Traffic Engineering Assessment Amendment C155 to the Glen Eira Planning Scheme

East Village Planning Panel

STATEMENT TO PLANNING PANELS VICTORIA BY JASON LEE WALSH, TRAFFIC ENGINEER

Figure 20: Landowner Proposed Connector Street Cross-section – 23 metres

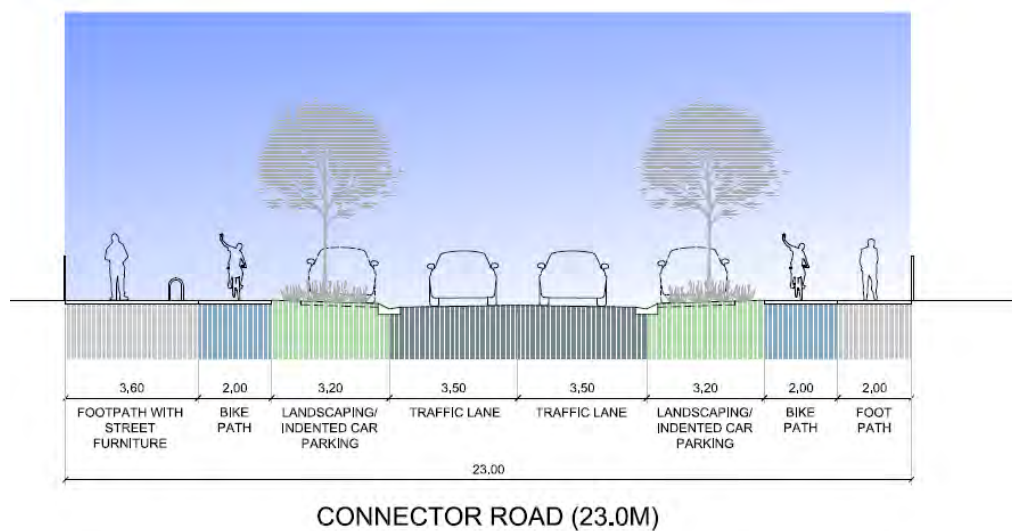
The reduced cross-section proposed by the Landowners includes 3.5 metre traffic lanes, which are appropriate for a bus capable road, and continues to provide footpaths of similar, or larger, width than that shown in the CDP.

Accordingly, I am of the view that the alternative cross-section will provide for a comparable function for all users (ie cars, pedestrians, buses and bicycles) to the CDP proposed cross-section, but with a more rationalised arrangement.

Should there be a desire to have a single two-way shared bicycle path on one side of the road this could be co-located on one side of the road as a 3.0 metre shared path.

Figure 21: Landowner Proposed Local Access Street Cross-section – 15.5 metres

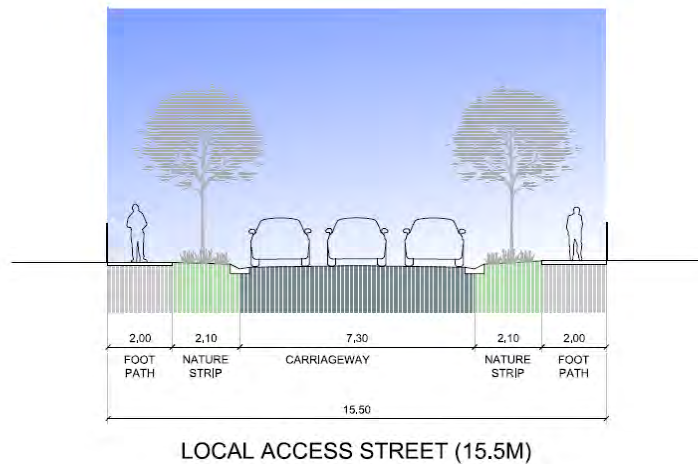
The key difference between the Landowner proposal and this arrangement is a reduction in the nature strip widths. From a traffic and access perspective, there is no material difference in this arrangement and, therefore subject to servicing and landscaping requirements, this cross-section is acceptable from a traffic perspective.

Figure 22: Landowner Proposed Local Access Street Cross-section – 14.5 metres

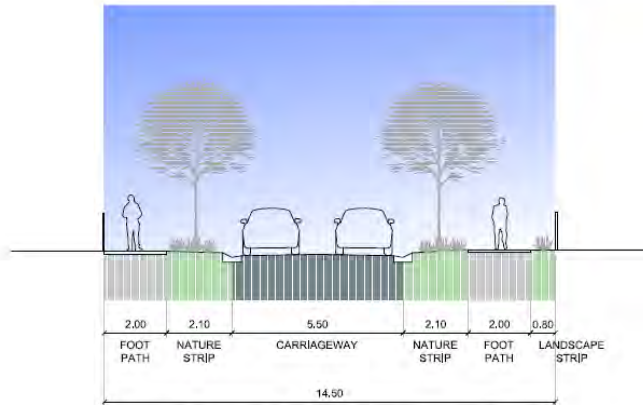
I understand this cross-section is provided as an alternative to the 16 metre Local Access Street cross-section provided in the CDP. It would appear to relate to a single road along the eastern boundary of the precinct, and a small extension of North Drive to the east of Cobar Street

The key difference is the removal of the bike path and replacement with a footpath.

From a vehicular and pedestrian access perspective, there is no material difference in this arrangement.

Figure 1: GTA Traffic Volumes (future including growth) for North Road - AM Peak

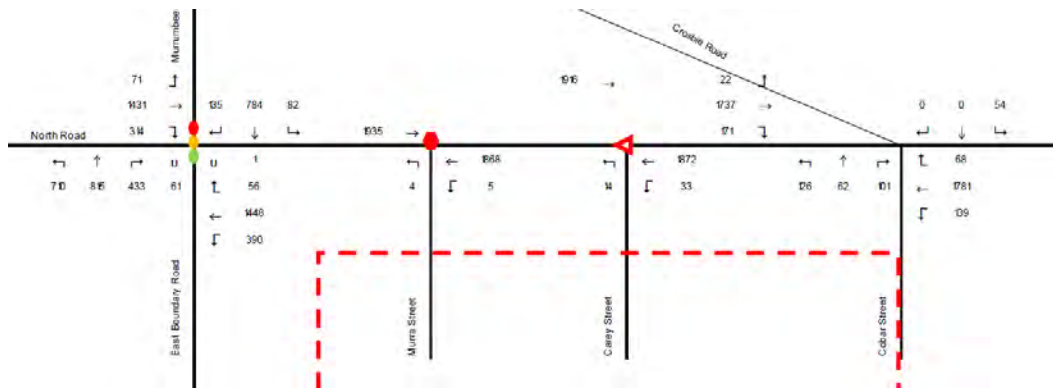
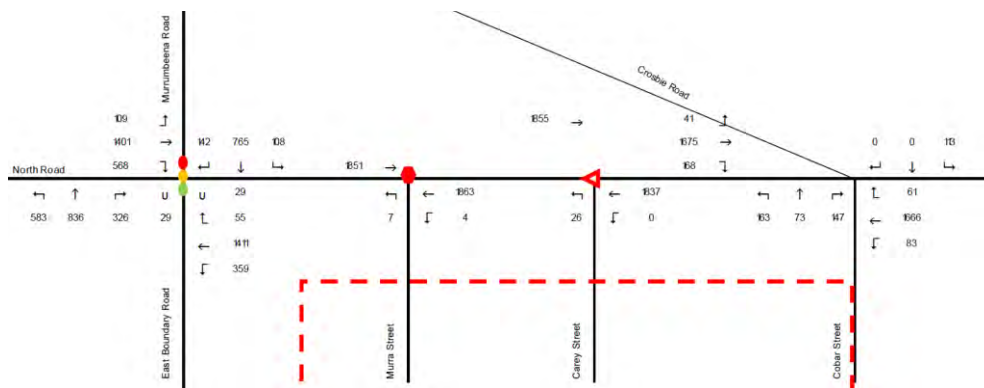
- With regard to DoT's perceived 'need' for the left turn deceleration lane from the east, Figure 1 and Figure 2 (over page) are extracted directly from the GTA report showing the future traffic volumes expected along North Road (including growth).

Notably, at the East Boundary Road intersection, the left turn from the east is significantly higher, representing a much higher proportion of westbound through movements.

- To identify the capacity benefit of providing the left turn deceleration lane (as requested by DoT in their submission for 70 metres – modified for services), we have remodelled the network to include a left turn deceleration lane from the eastern leg.

Figure 3: South Drive - GTA Modelling AM Peak Hour Volumes

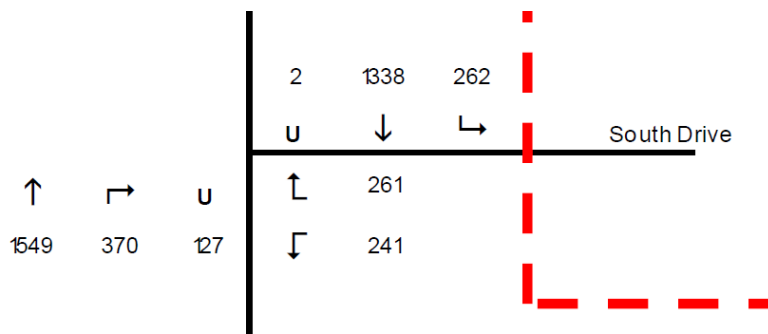
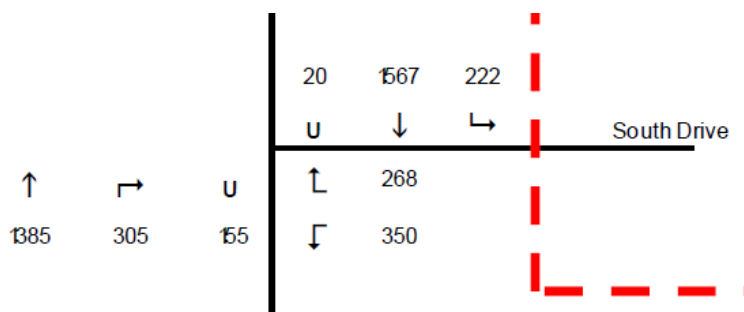
- We understand service proving is being undertaken to confirm the location and impact of services. Further information can hopefully be provided in due course.
- Additional confirmation that the southbound direction, DoT requested a review of left turn volumes and comparison of the results if a third through lane were provided in the southbound direction, with a shared left turn lane, or slip lane.

SIDRA Results comparing the different scenarios of a deceleration lane with slip left turn (as proposed) vs provision of a third through lane with a slip (but no deceleration lane) vs a third shared through and left turn, with no slip lane, is provided in Table 6 for information.
